Draft Issue 2 [27/11/02]	Pressure Seal Systems Ltd. 1 The Dean New Alresford Hampshire SP800		
	PS800 CONTACTOR UNIT [DV] - 3x240/60Hz/PE		
Size A2	FCSM No.	DWG No.	48-0003-01
Scale			Sheet 4 of 0

Title: ENTRY COVER WIRING DIAGRAM		
Rev: A1	Number: 48-0004-00	Revision: Draft C
Date: 10 Jan 2003	Drawn by: [Name]	Sheet of: [Total]
File: C:\Documents and Settings\jls111\My Documents\Copy of Draft C 13/01/2003

Title PS80 SYSTEM LEVEL CONNECTIONS [3x208-230V/60Hz]		
Size A2	Number 48-0001-00	Revision Issue 2
Date 16-Jan-2006	Sheet of 1	File C:\Documents and Settings\jmillard\PS80\Documents\COPY of Millard (J)\R&D\Elect

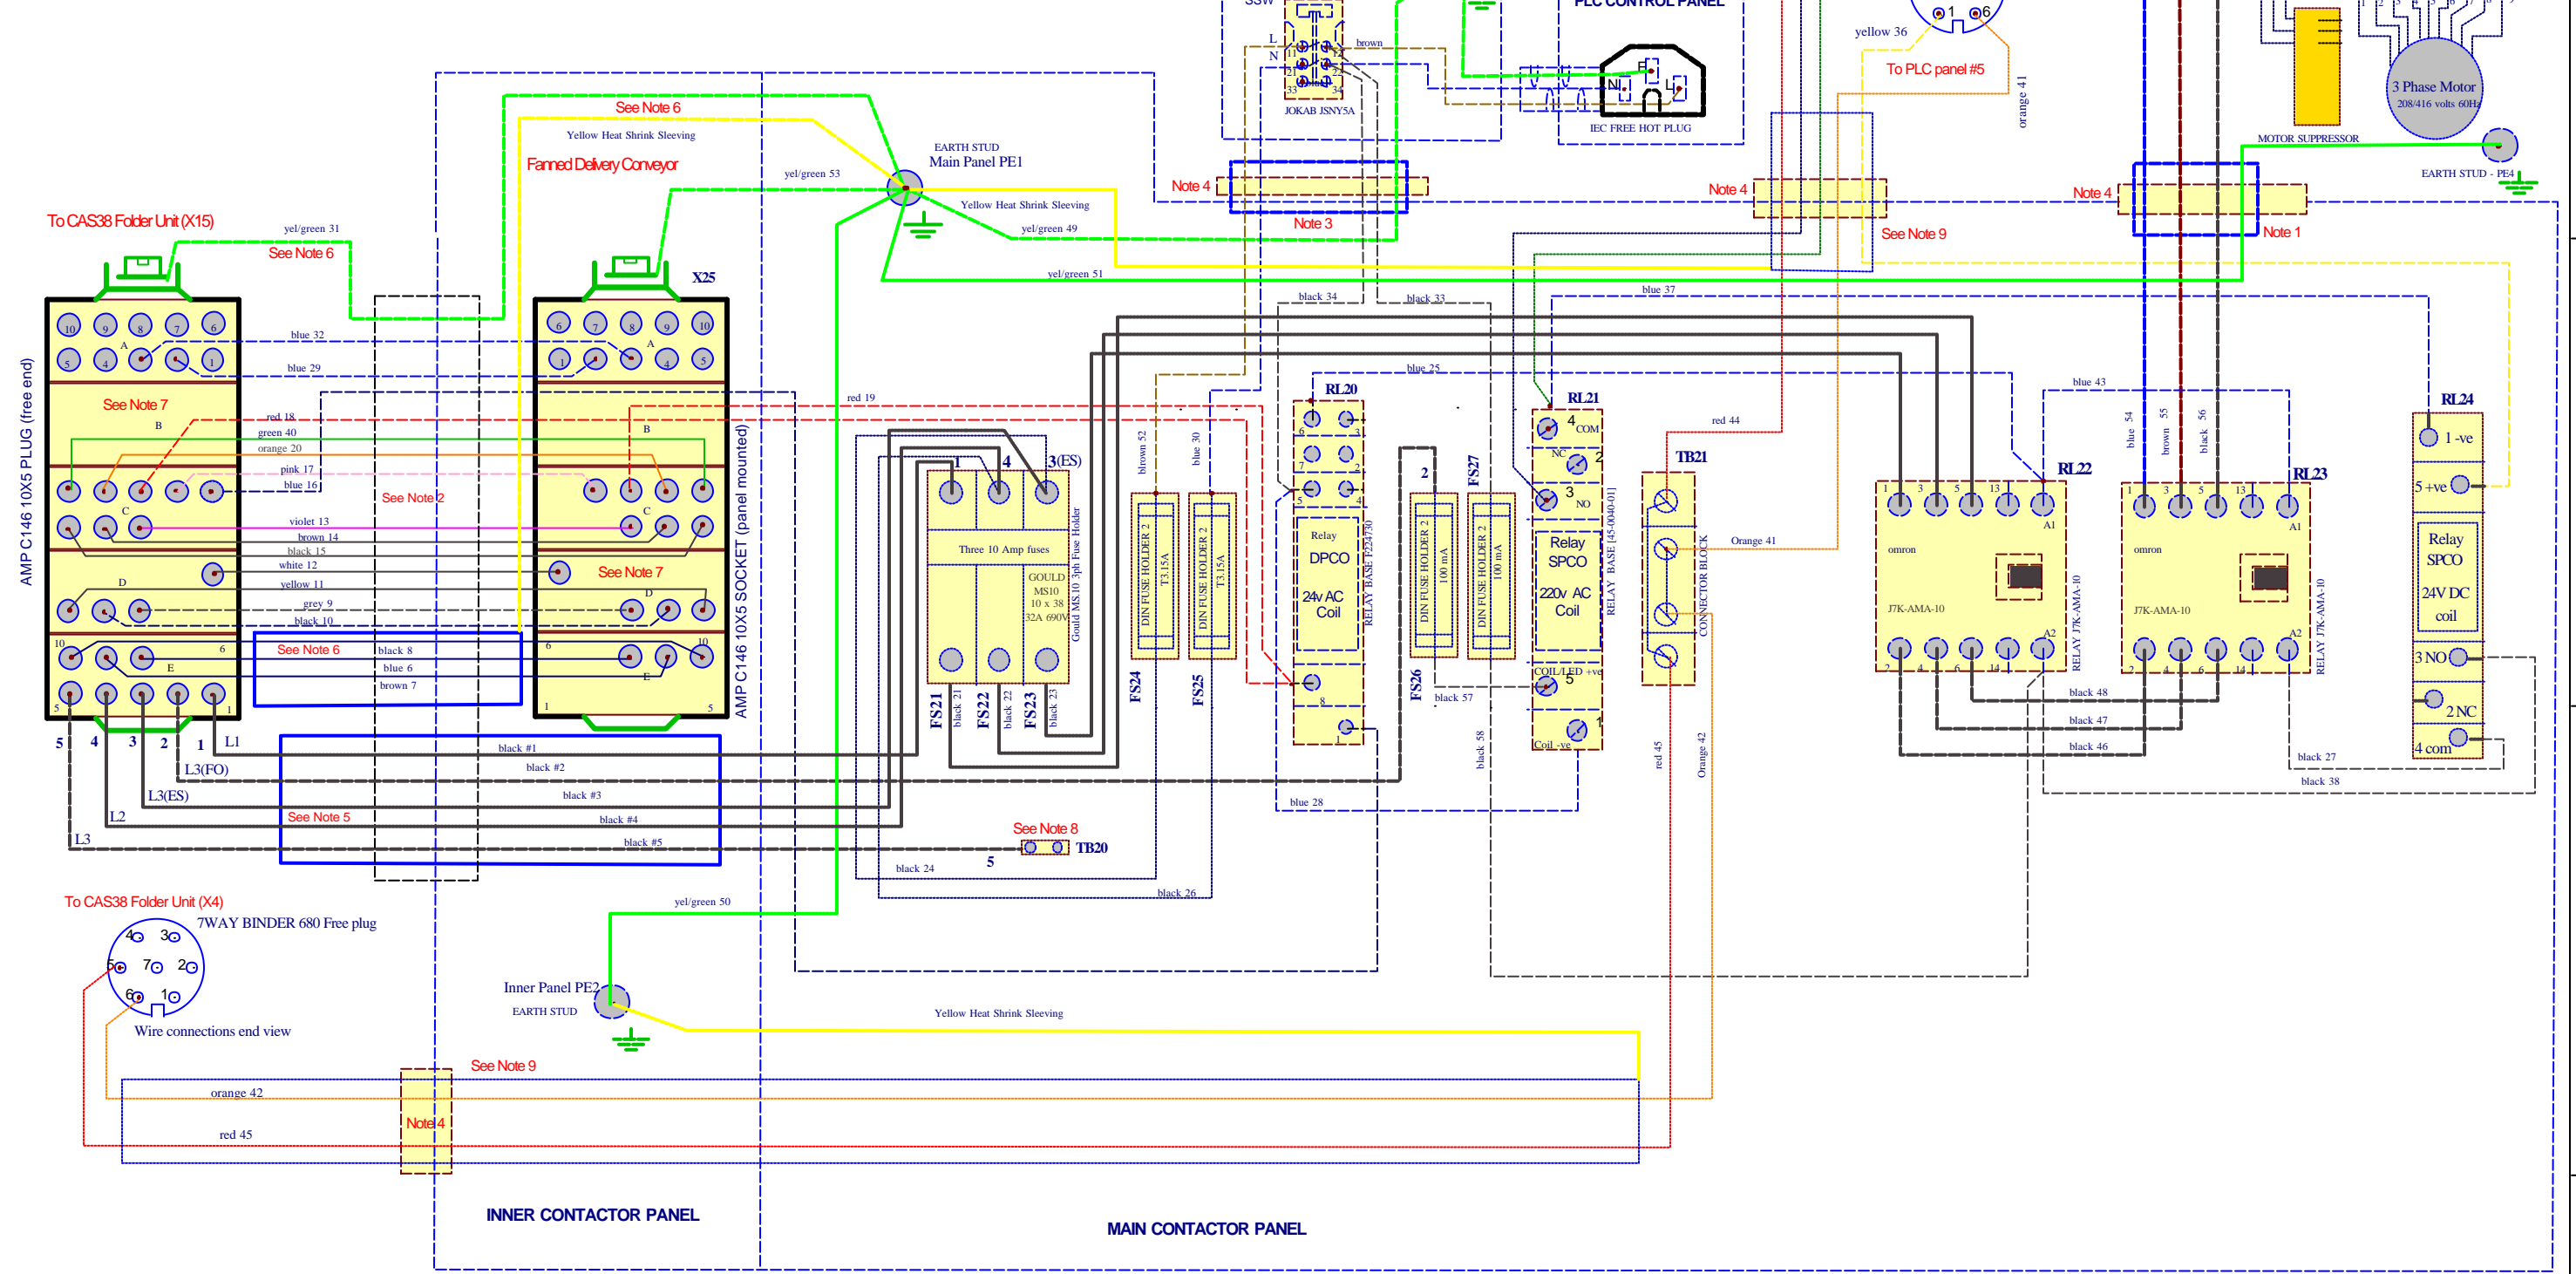
Issue 2 - 27/3/02 CRN changes: New relay type for RL22 and RL23 - both have 240v AC coil. Wiring to the lid safety switches (SSW 21 & 22) changed. Two fuse holders removed from the Control Unit and installed in the Contactor Unit. Fuse identities changed to being numbered from the left. 4 DIN rail clamp type connector blocks (C21 to C24) removed and replaced by a terminal block (TB21) and 2 fuse holders (FS24 and FS25) which provide power to the Control Unit. Wire numbers 1,3, 4, 21, 22, and 23 re-routed. RL24 added - a 24vDC coil relay used to switch the new motor contactor relay RL23. Note 9 added.

w0002 - 14/04/03: Wiring to 10A fuses changed with line moved to the top and load to the bottom.

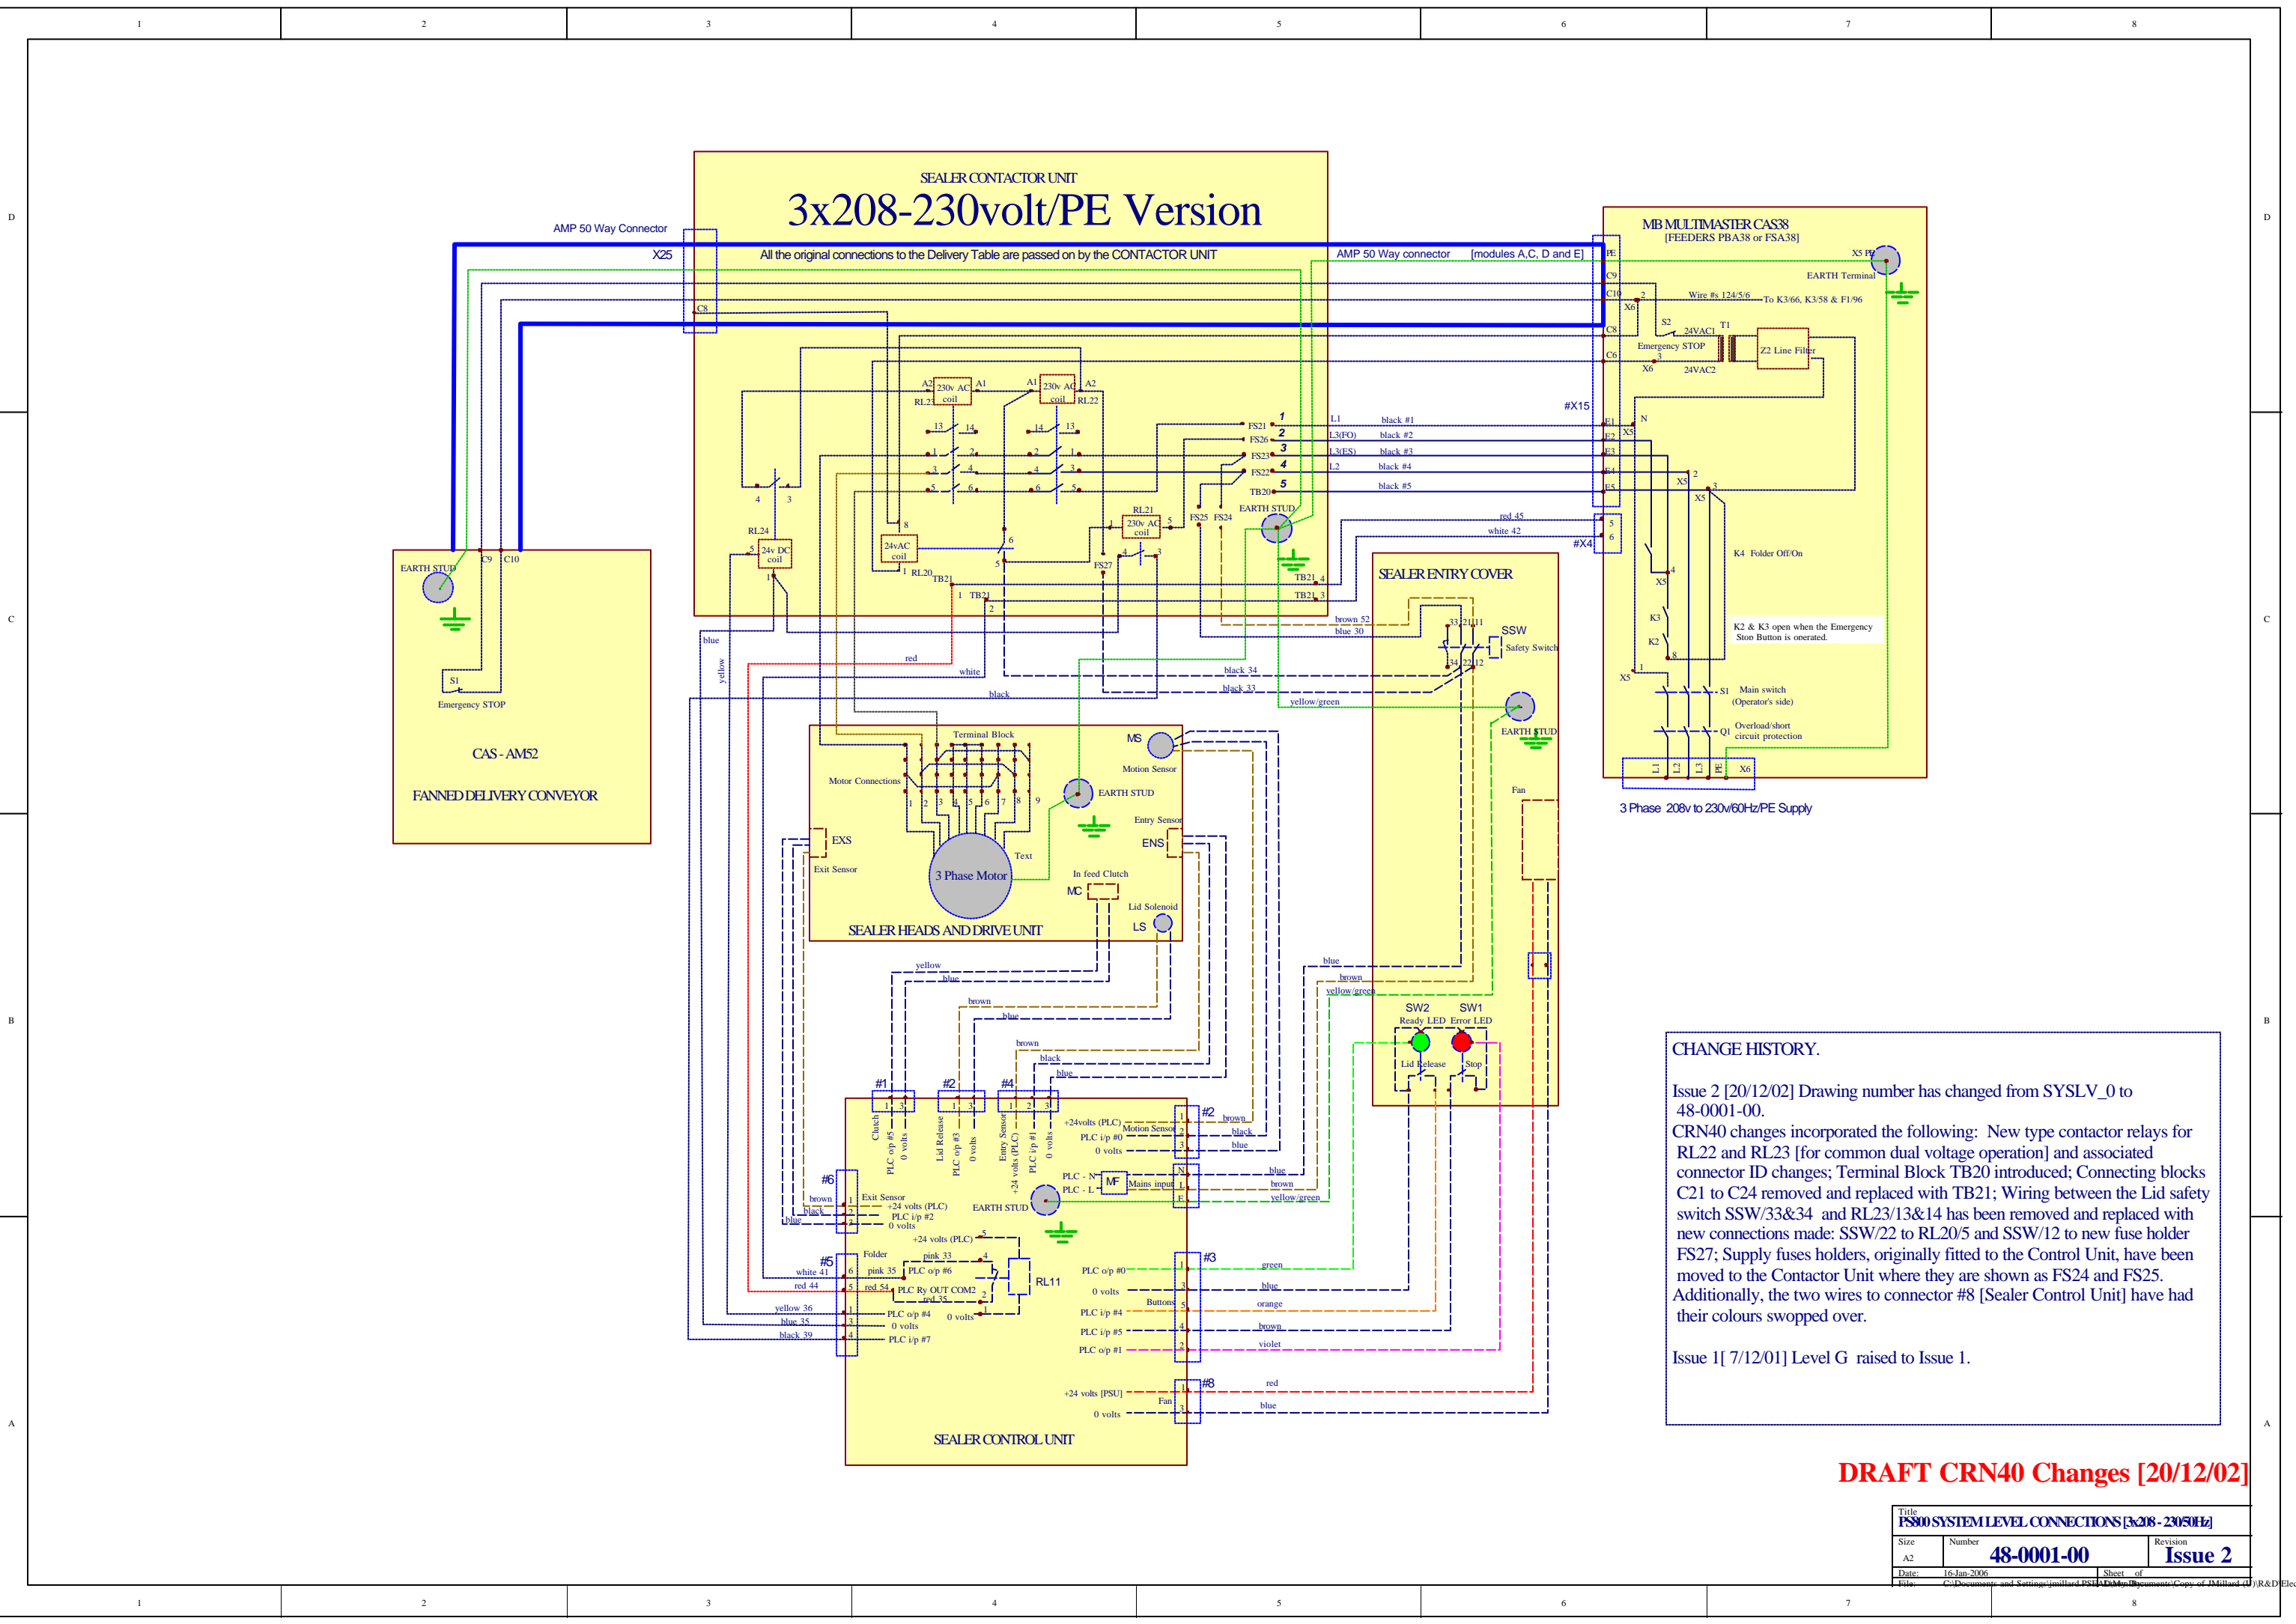
Issue 2 [20/12/02] Drawing number has changed from SYSLV_0 to 48-0001-00.

CRN40 changes incorporated the following: New type contactor relays for RL22 and RL23 [for common dual voltage operation] and associated connector ID changes; Terminal Block TB20 introduced; Connecting blocks C21 to C24 removed and replaced with TB21; Wiring between the Lid safety switch SSW/33&34 and RL23/13&14 has been removed and replaced with new connections made: SSW/22 to RL20/5 and SSW/12 to new fuse holder FS27; Supply fuses holders, originally fitted to the Control Unit, have been moved to the Contactor Unit where they are shown as FS24 and FS25. Additionally, the two wires to connector #8 [Sealer Control Unit] have had their colours swapped over.
